# Interactive comment on "Removal of radio N-nitrosodimethylamine (NDMA) from drinking water by coagulation and Powdered Activated Carbon (PAC) adsorption" by J. Chung et al.

Responses to Comments for Reviewer #1

Fig. 5.

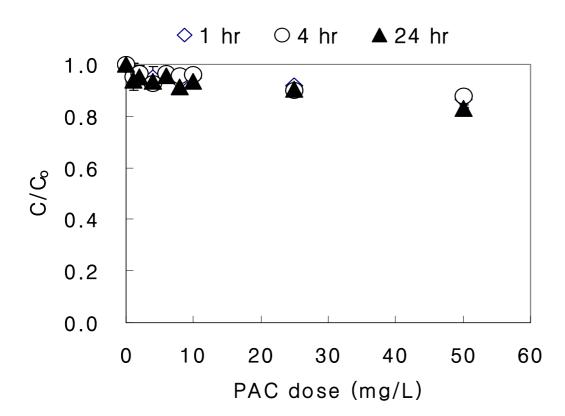
Comment 6. Figure legends in one or between figures should be generally identical (please unify their font and size). In particular, the legends in Figure 5 should be corrected: MF with out PAC and MF (UF) with out PAC Finally, a reviewer recommends author(s) to correct grammatical errors of the manuscript with native English speakers. If author(s) takes into account all the above factors, the article can be accepted for publication in the Journal. Response: Thank you for the valuable comments. We have revised those as suggested.
